# RENESAS TECHNICAL UPDATE

Product Category	MPU/MCU		Document No.	TN-SH7-A874A/E	Rev.	1.00
Title	SH7450 Group, SH7451 Group User's Manual Hardware Errata Rev. B		Information Category	Technical Notification		
Applicable Product	SH7450 Group, SH7451 Group	Lot No.	Reference Document	SH7450 Group, SH7451 Group User's Manual: Hardware Rev. 1.10 (R01UH0286EJ0110)

We inform you of the corrections of "SH7450 Group, SH7451 Group User's Manual: Hardware Rev. 1.10 (Published on September 27, 2011)".

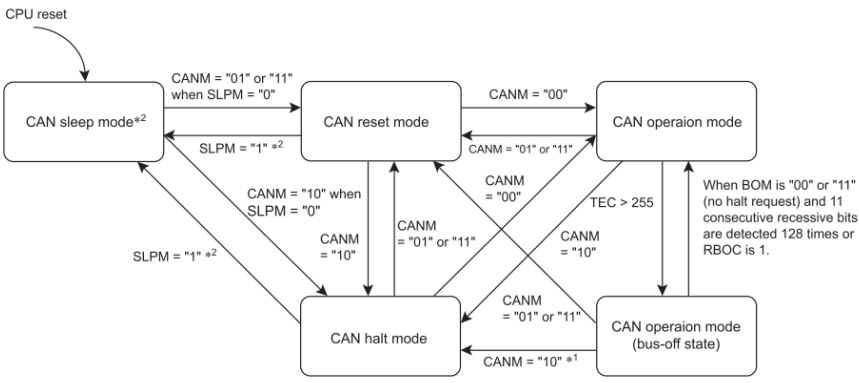
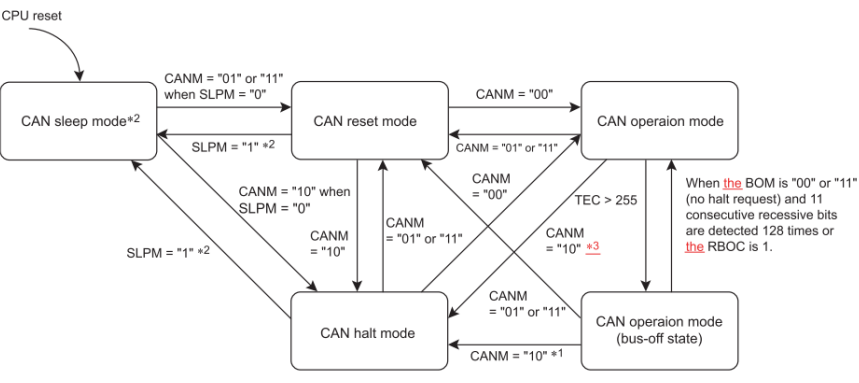
Item	Symbol	Min.	Max.	Unit	Figures																						
AUDRD output delay time <b>after</b> AUDRCLK	td(AUDRCLKH-AUDRD)	-	40	ns	38.46																						
Added in Rev. B	12-8	12.3.2 Flash Access Status Register (FASTAT)	<p>Description of the bit 7 (ROMAE bit) in the Flash Access Status Register (FASTAT) is corrected.</p> <p>Error: An access command is issued to an address other than ROM program/erase addresses H'FD80 0000 to <b>H'FD9F FFFF</b> when the user boot MAT is selected.</p> <p>Correction: An access command is issued to an address other than ROM program/erase addresses H'FD80 0000 to <b>H'FD80 7FFF</b> when the user boot MAT is selected.</p>																								
Added in Rev. B	12-23	Figure 12.8 Command State Transitions in ROM Read Mode and P/E Mode	<p>Figure 12.8 Command State Transitions in ROM Read Mode and P/E Mode : Incorrect description is corrected.</p> <p>Error:</p> <p>Correction:</p>
